These drawings are submitted as a non-material amendment to the approved application 230252.

Old Grain Store, Swallowfield Road, Arborfield, RG2 9LA

Barn Conversion

CLIENT
Mr. Nigel Clyde
TITLE
Plans - Ground, First & Roof Levels - Proposed GA

SIZE
A1
REFERENCE
MAB-C4903-400

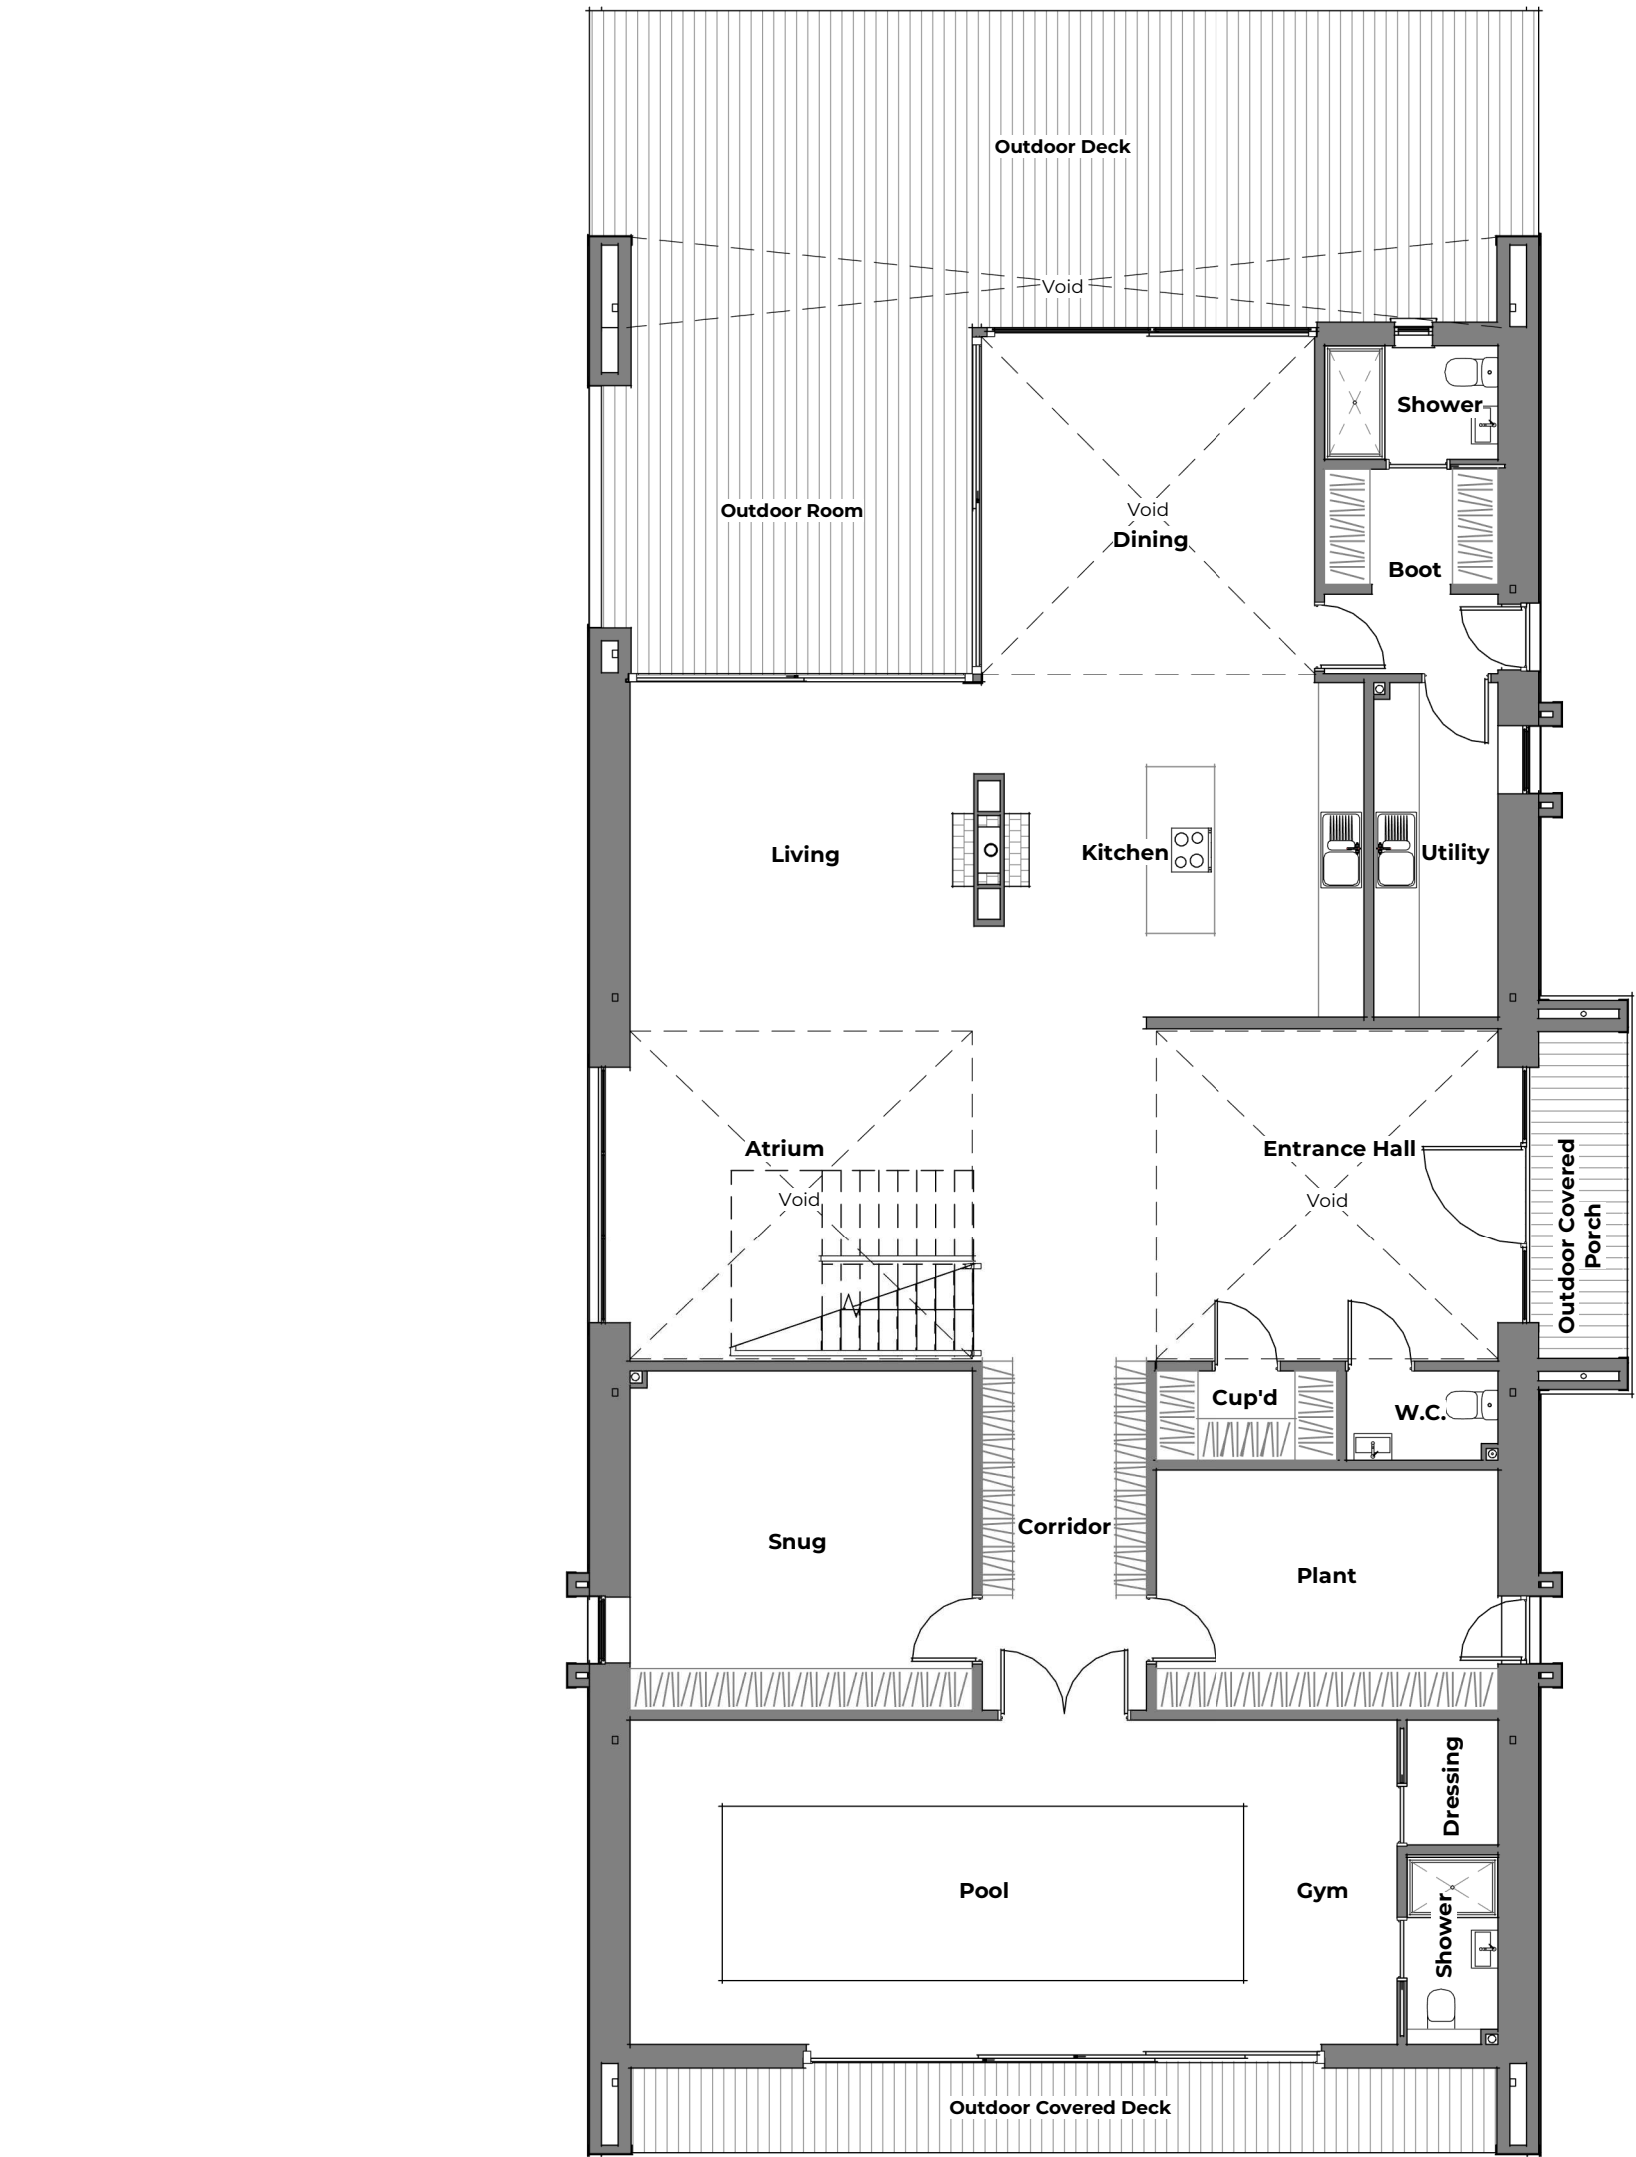
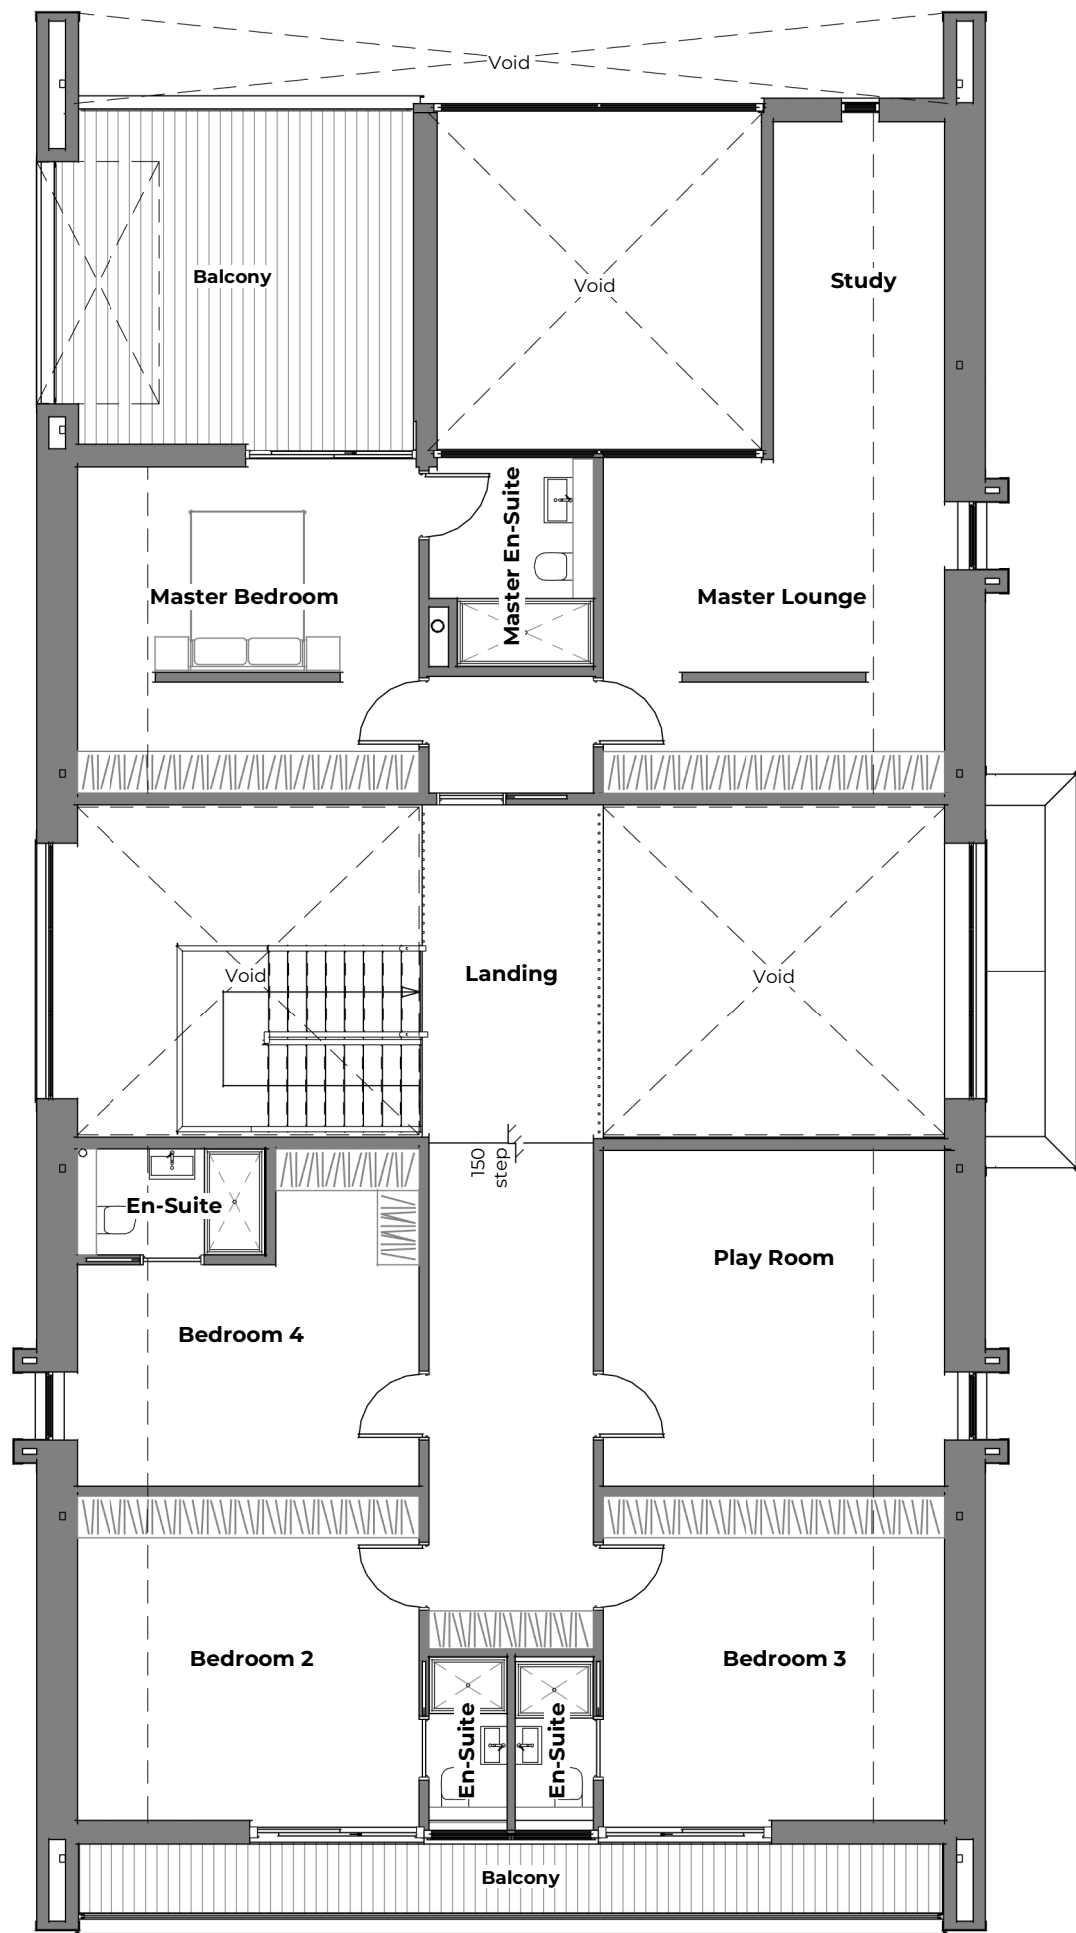
Drawings MAB-C4903-400-0 & MAB-C4903-480-0 seek to supersede approved drawings PPL-113-B & PL-114-A

- Changes affecting elevations are noted in red and include:
- Small internal layout (larder replaced with shower; playroom swapped with bedroom 4)
 - Small rooflights to first floor rooms removed
 - Protruding two storey slot windows of black colour added to east and west elevations
 - New window to master lounge, playroom and bedroom 4 added
 - Window to pool room removed
 - Window to utility room dimensions changed
 - Rooflights made upstand & separated from wall glazing
 - North elevation glazed wall reduced to narrow slot windows
